Village of Arlington Heights
Plan Commission
Board Room, 3rd Floor
Arlington Heights Village Hall, 33 S. Arlington Heights Rd.
September 25, 2019
7:30 PM

File Number: PC 19-009
Project Title: LaSalle Estates Subdivision
Address: 2000 N. Chestnut Avenue
PIN: 03-18-401-085

PRELIMINARY PLAT OF SUBDIVISION
THE LASALLE ESTATES
LASALLE STREET
ARLINGTON HEIGHTS, ILLINOIS

EXISTING CONDITIONS & TREE PRESERVATION PLAN

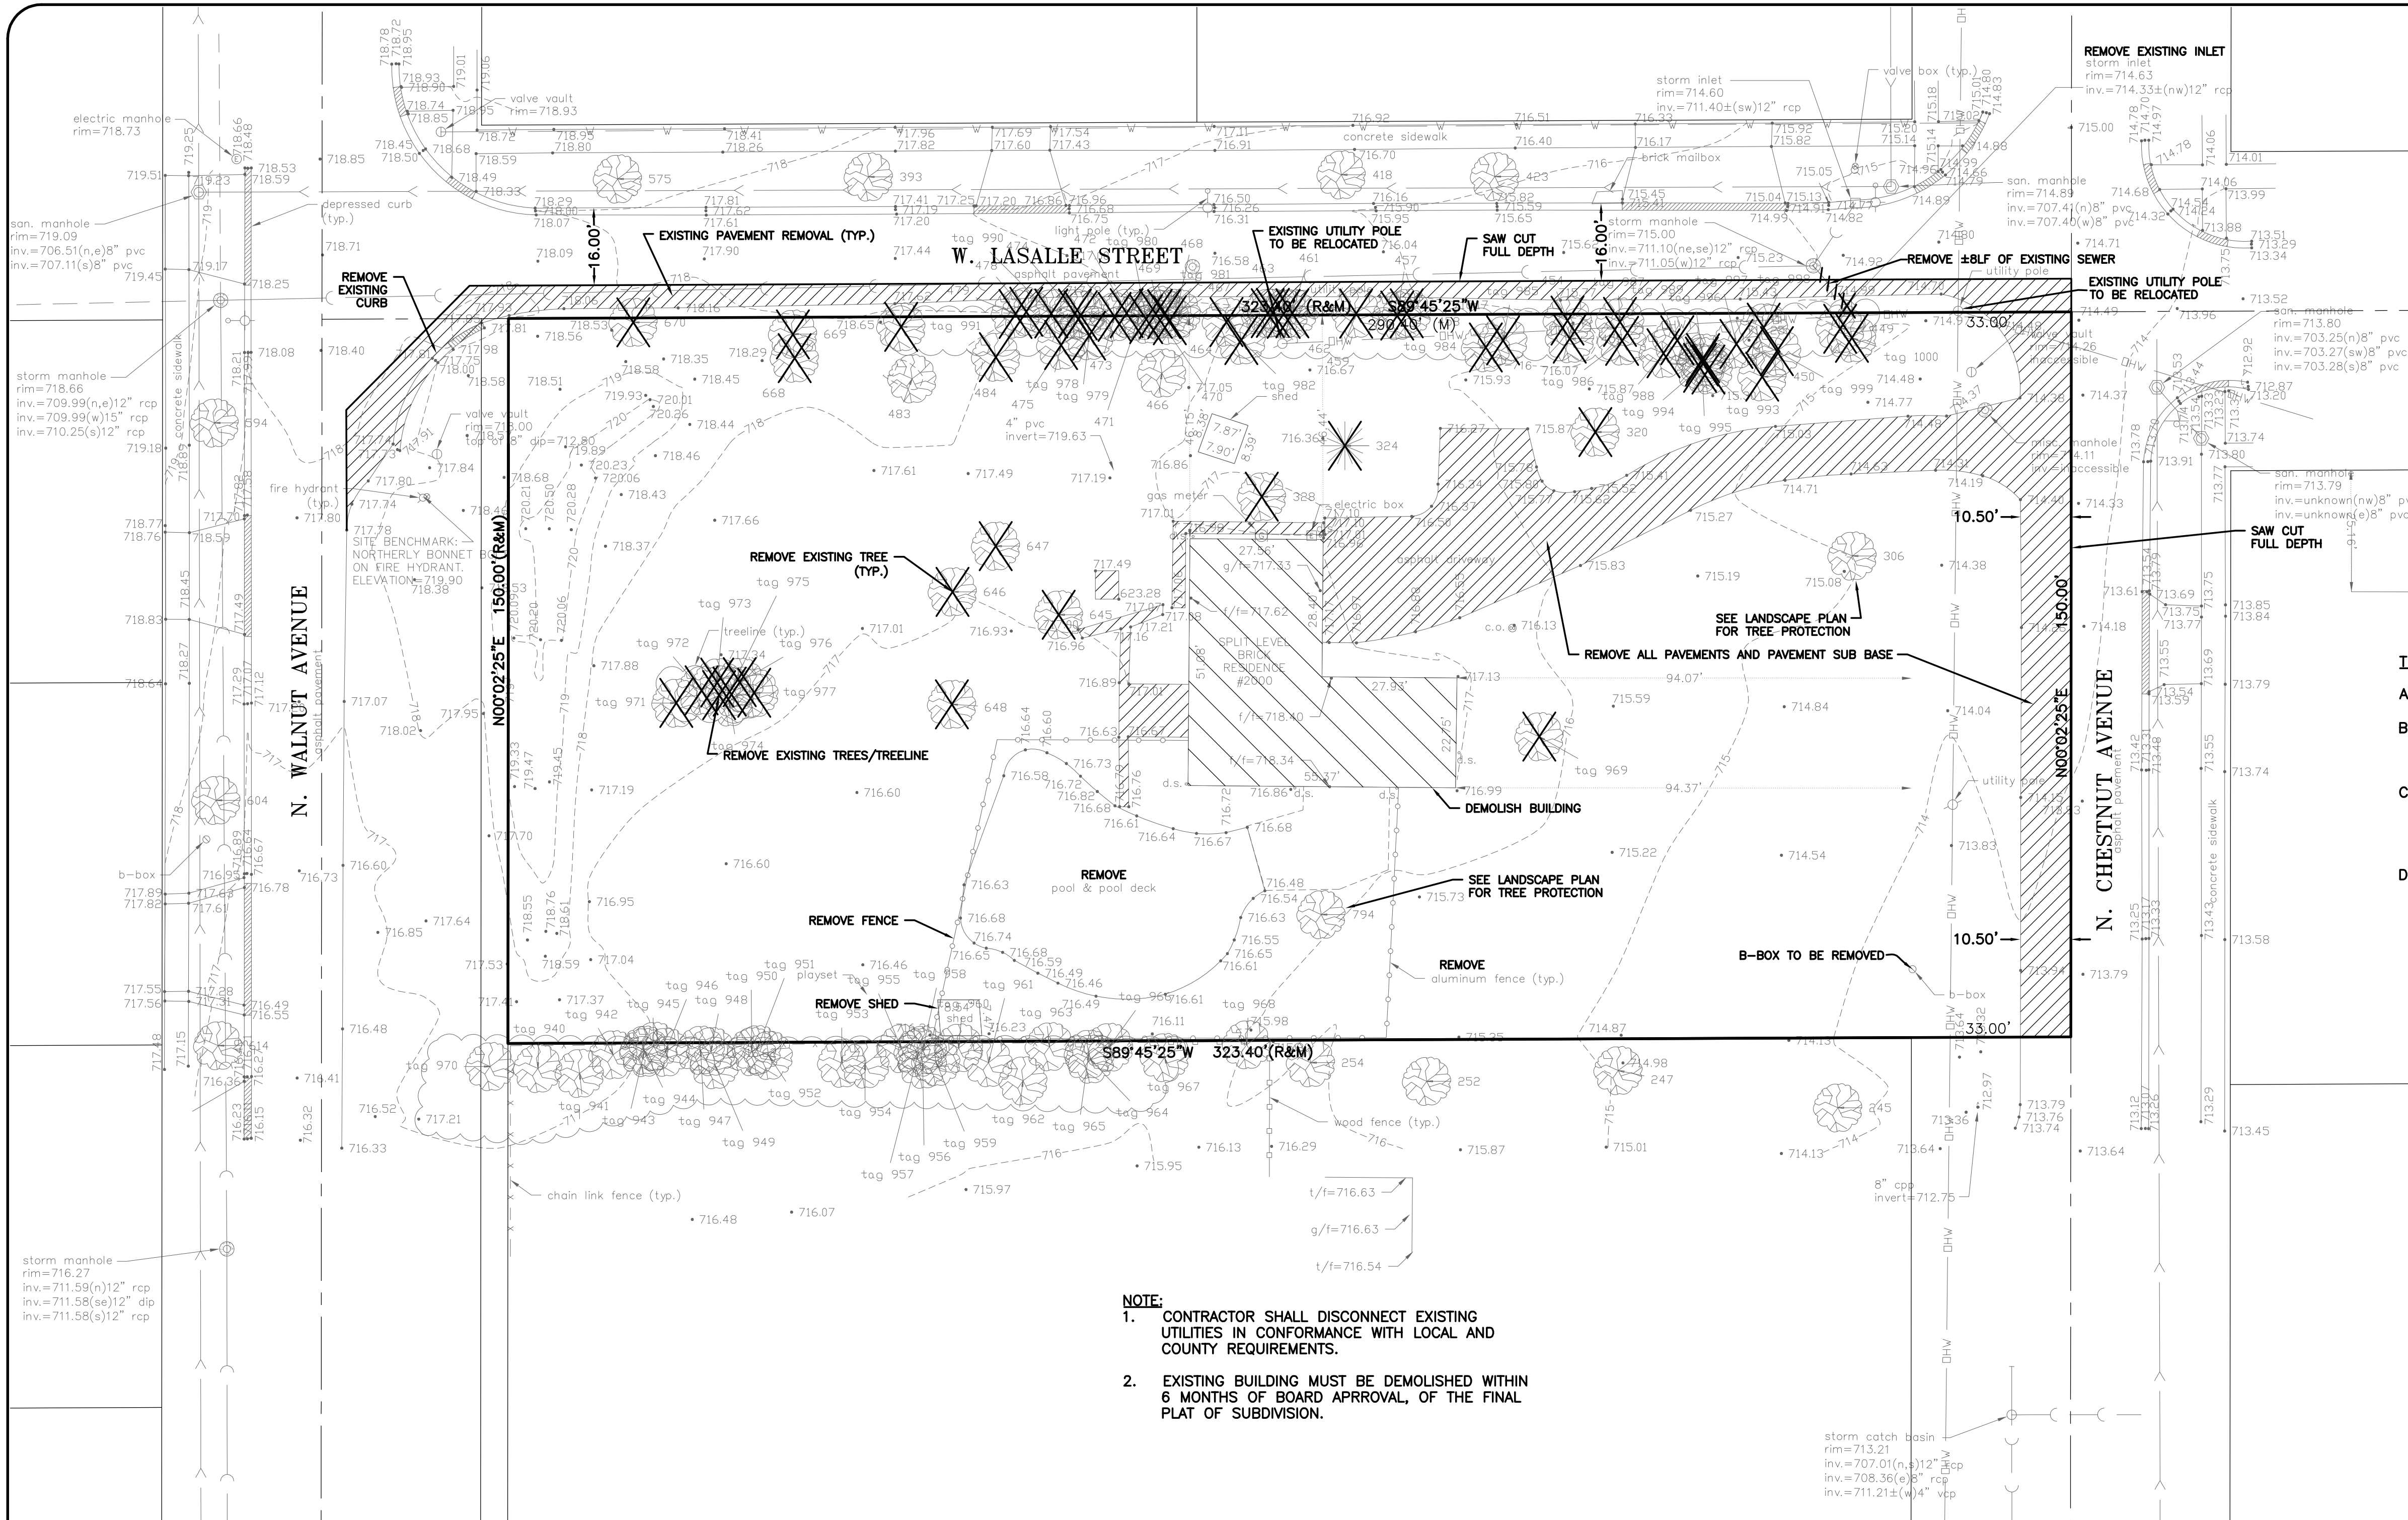
7. The tree preservation and landscape plan shall be revised so that the 8" Mulberry tree that is slated for preservation shall be removed and replaced with a State Street Maple tree, and the three State Street Maple trees proposed along Chestnut Avenue be revised to be Ivory Silk Japanese Lilac trees.

The Public Works Dept. has asked for some minor changes to the tree preservation plan, such as the removal of an 8" Mulberry tree that is slated for preservation and its replacement with a Maple tree, and switching out the species of the proposed parkway trees along Chestnut. Staff has incorporated these recommendations as conditions of approval below.

SITE DEVELOPMENT PLAN

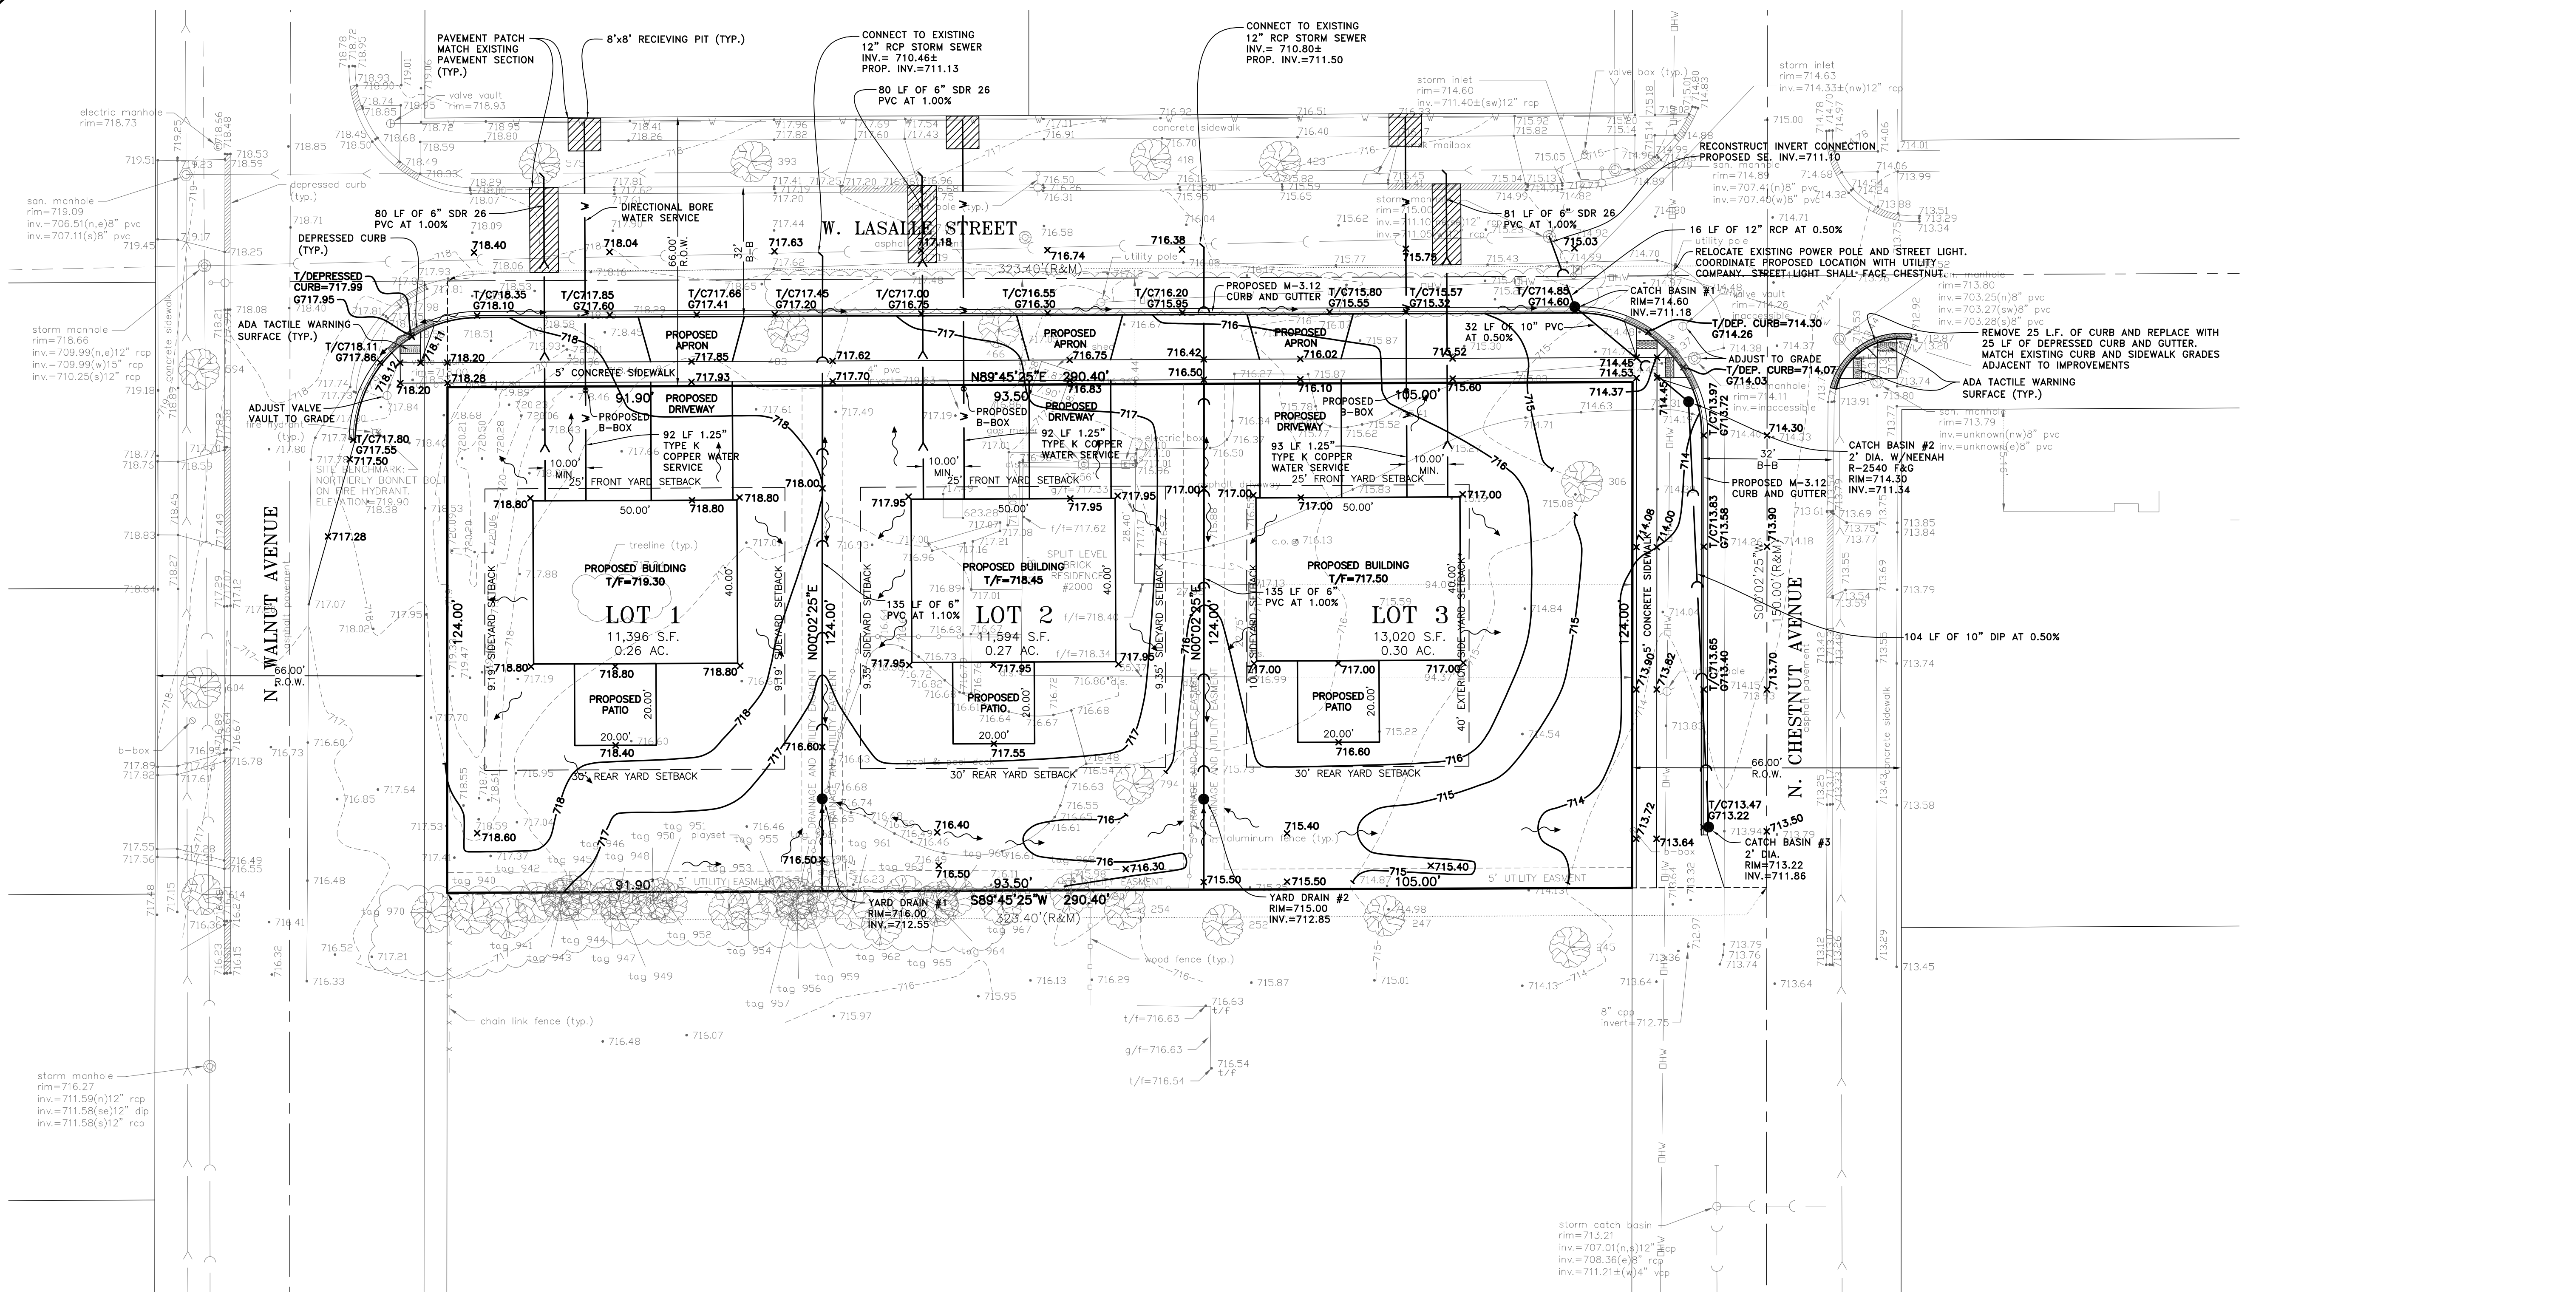
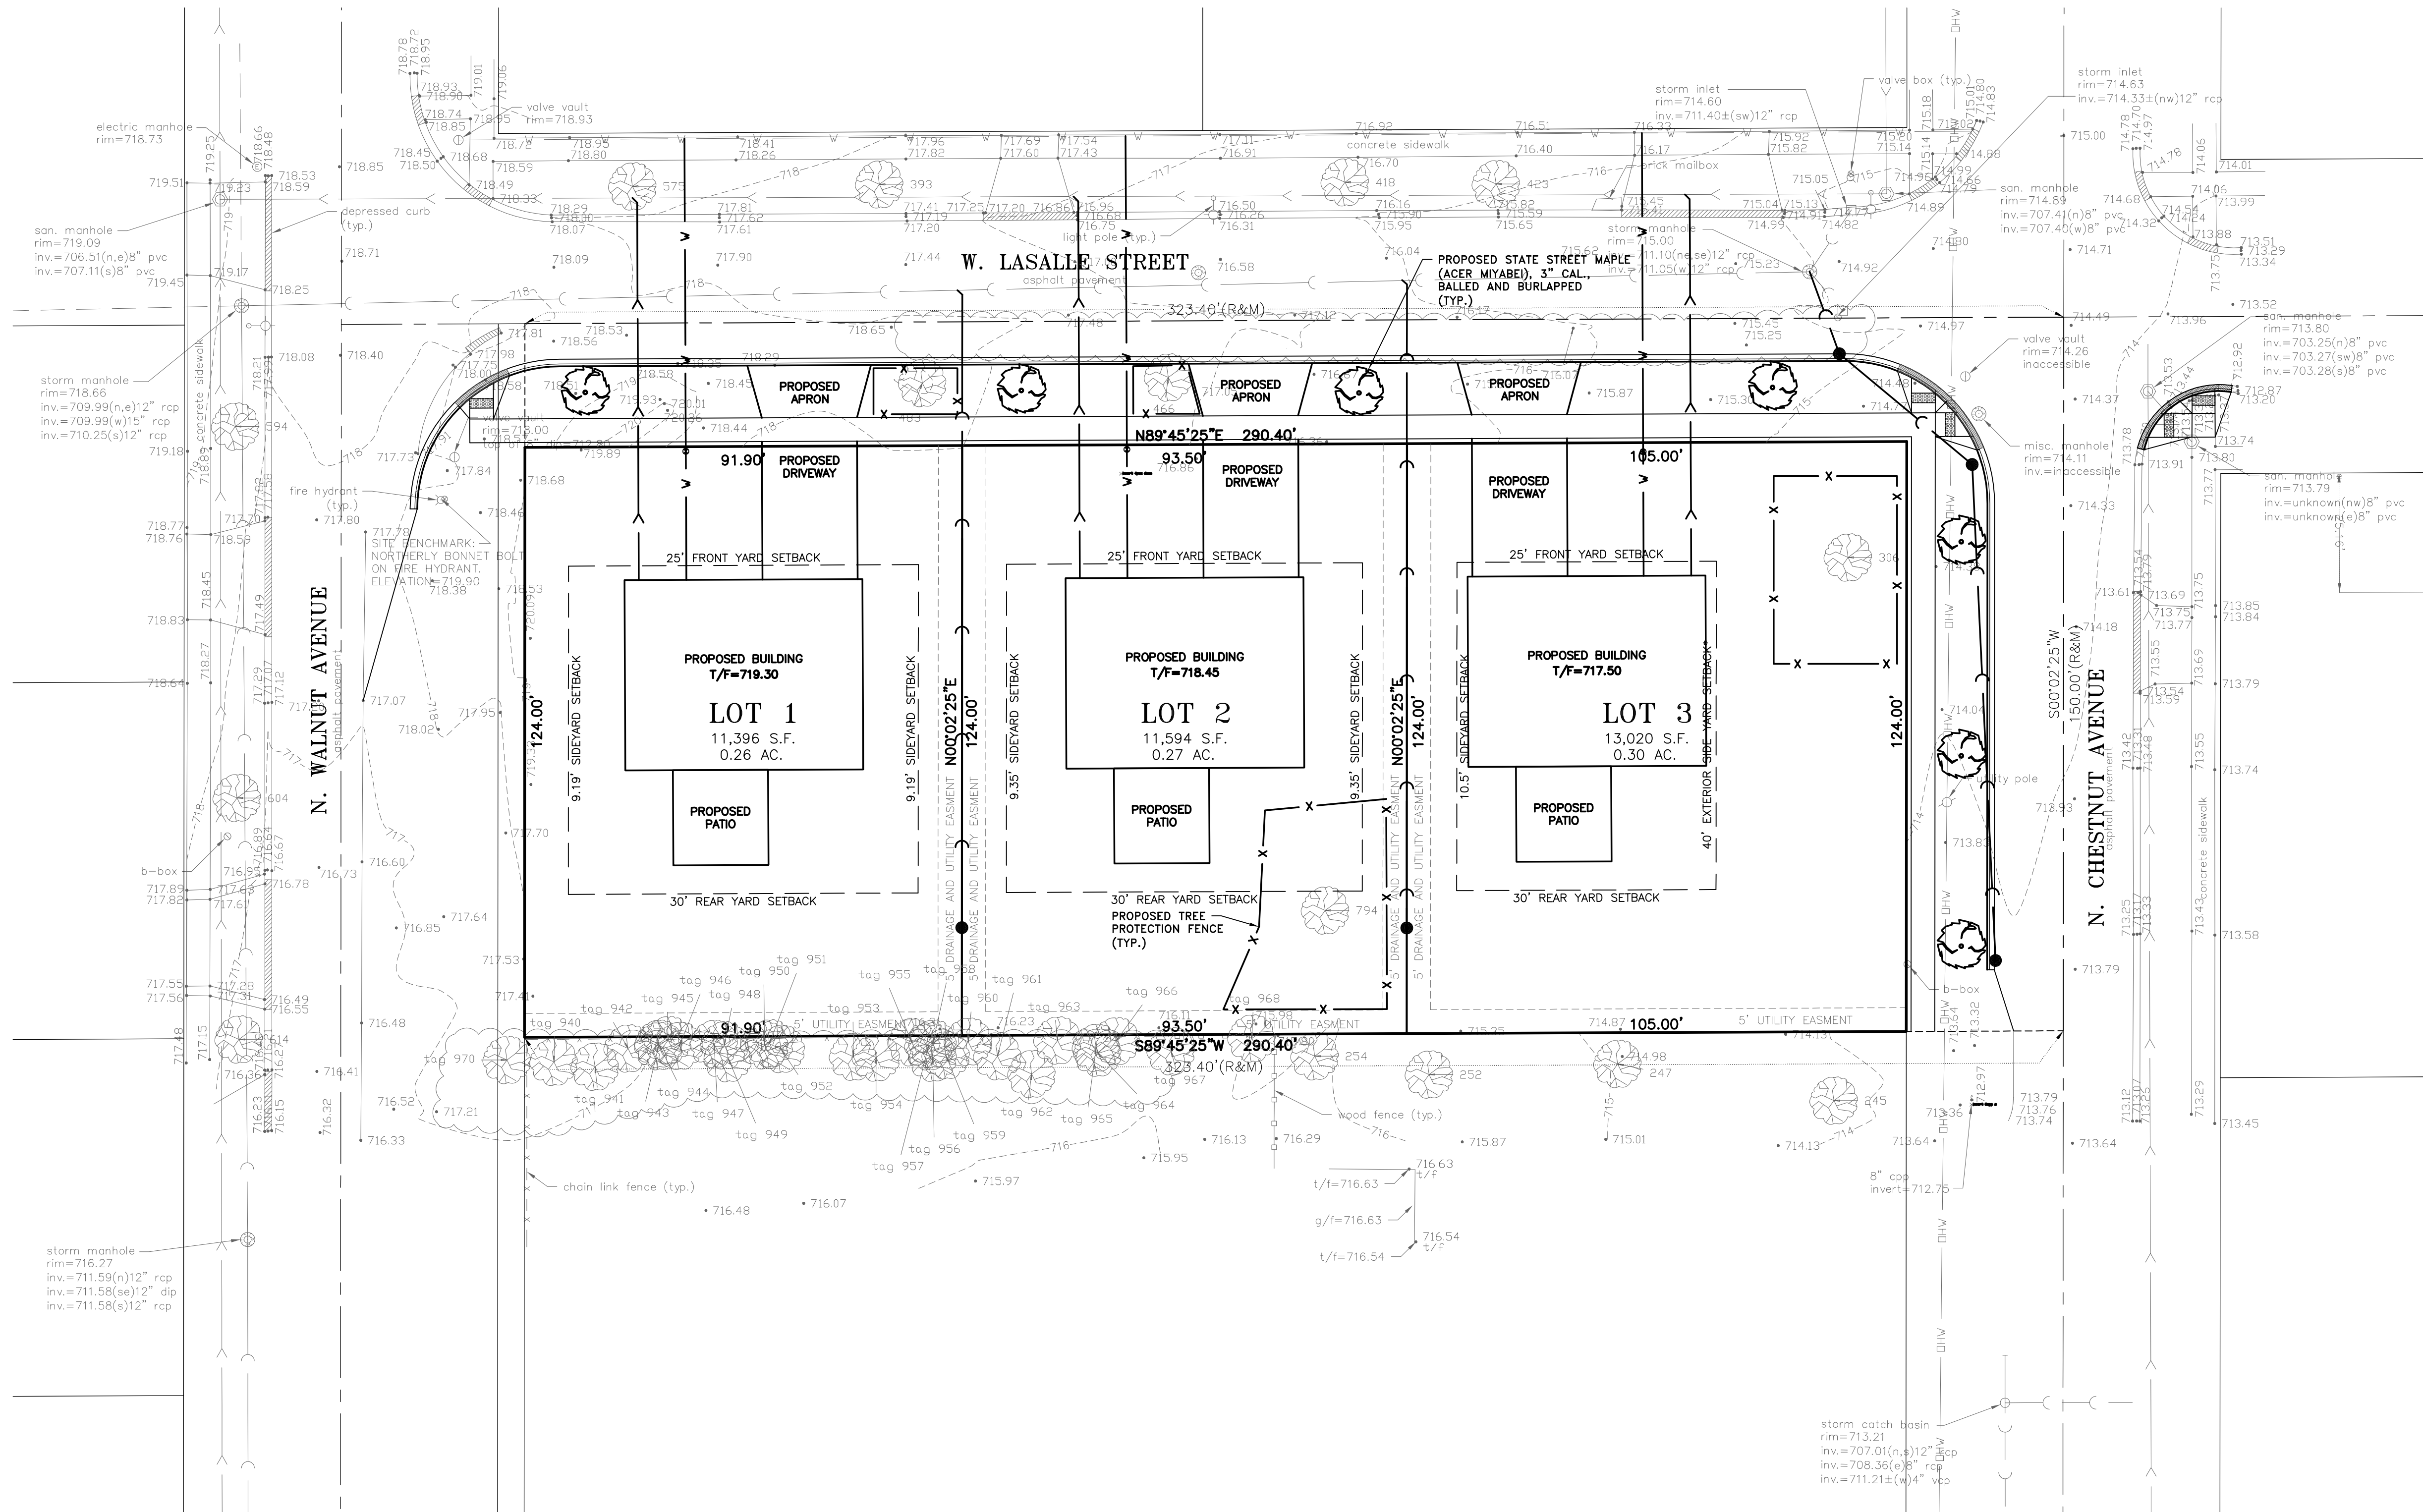
17. The proposed cross section for a local street shall consist of 2" N50 surface, 2 1/4" N50 surface, 5" N50 binder, and 4" CA-6. Verify the existing curb on the east side of Chestnut Ave and the north side of LaSalle St. If the existing curb is B-4.12, match existing curb. Revise the cross section accordingly.

18. The proposed ADA ramps shall be constructed to meet the Public Rights-of-Way Accessibility guidelines and IDOT standard detail 222-424001-11 Perpendicular Curb Ramps. New ramps should also be constructed at the SW and SE corners, providing an east/west pedestrian access route across Chestnut Ave.

25. The response to comment #16 is noted. The Village is requesting that you modify the western side yard setback for Lot 1 from 9.19' to 20' as this yard will function more like an exterior side yard given the proximity to Walnut Avenue. Of note, staff is supportive of a variation to Lot 3 to reduce the western exterior side yard setback from 40' to 30'. Please adjust the plans if this reduction is desired for Lot 3. Of note, the setback for Lot 1 (and potentially Lot 3) will also need to be adjusted on the Engineering Plan sheets 3, 4, and 5, as well as on the Preliminary Plat.

18. ADA ramps follow IDOT guidelines. IDOT detail 222-424001-11 added to plans. New ramps for the southeast and southwest corners at Chestnut added to plan.
